REFERENCE: RECON 25/0152

PROPOSAL: RESERVED MATTERS APPLICATION RELATING TO LAYOUT, SCALE, APPEARANCE, ACCESS AND LANDSCAPING FOR RESIDENTIAL DEVELOPMENT AT PHASE4E/4G

SITE: Glan Llyn Development Site Phase 4E/4G

Countryside and Conservation Landscape Comments

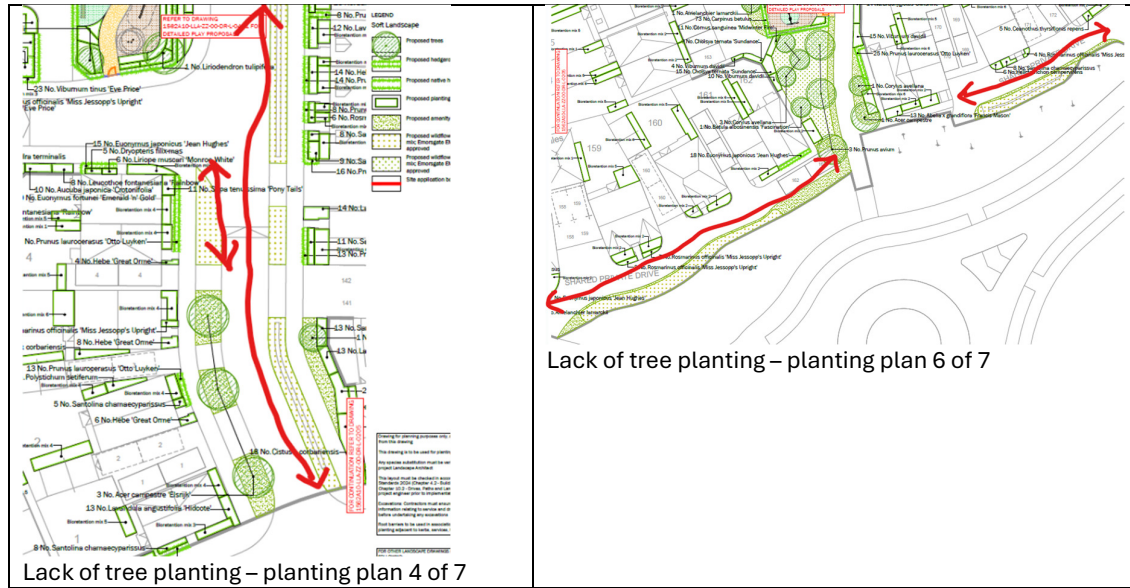
The road corridors highlighted below have no tree planting within the SuDS swales which will result in poor views dominated by a two-dimensional landscape of grass and hard surfaces. Swales are not a constraint to tree planting and proposals should be revised.

Lack of tree planting – planting plan 2 of 7 including opposite the bridging point across central lake ie a focal point

Lack of tree planting – planting plan 3 of 7
